E-mail	advancedtherapies-fsca.team@siemens-healthineers.com
Date	December, 2020
Corrective Action ID	AX044/20/S

Customer Safety Information (CSI) for Field Safety Corrective Action

Subject: Sensis Vibe Hemo systems with MicroPod™ EtCO₂

Figure 1: Example of broken connector

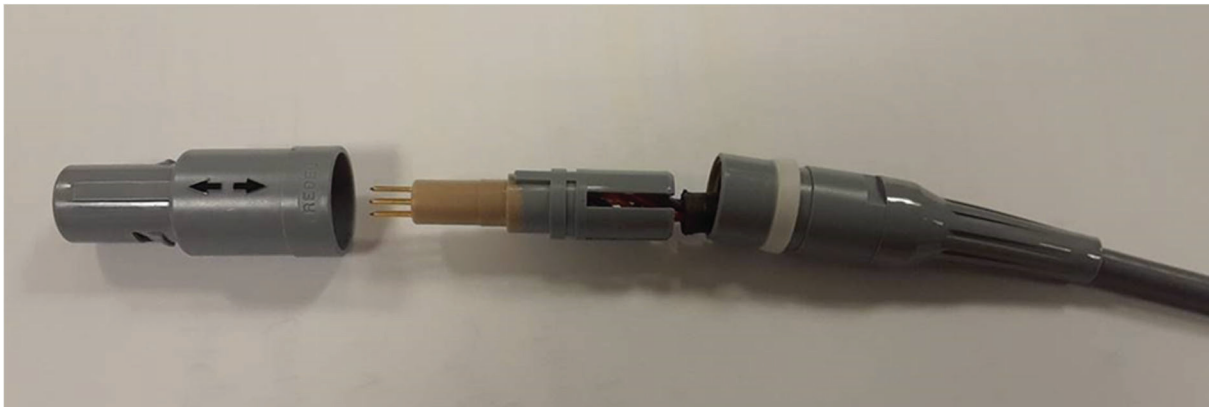
The connector joining the EtCO₂ module to the HemoBox may break and become damaged (see Figure 1). The damage to the connector may occur under certain conditions that place strain or unexpected force on the cable/connector. Examples include (but are not limited to) stretching of the cable due to table movement, collision of the connector with other equipment, or incorrect plugging/unplugging of the connector. If the connector is re-connected to the HemoBox in this damaged state, the contact pins may not be in the proper alignment.

If the connector is re-connected to the HemoBox in this damaged state, under certain incorrect pin alignment conditions, the HemoBox may stop functioning and all vital signs are lost until the EtCO₂ module is disconnected. When the module is not connected, EtCO₂ monitoring is not available.

The problem was identified by regular field observation. The connector robustness got assessed as not sufficient.

If the connector joining the EtCO₂ module to the HemoBox should become damaged or break, the operator shall not attempt to fix the connector or re-connect the cable to the HemoBox. Only a qualified electrician of Customer Service may resolve the issue.

The manufacturer optimized the assembly process of the connector resulting to increase the durability of the connector.

With this CSI, we provide the newly assembled MicroPod™ EtCO₂ (Revision 02) which replaces the MicroPod™ EtCO₂ (Revision 01).
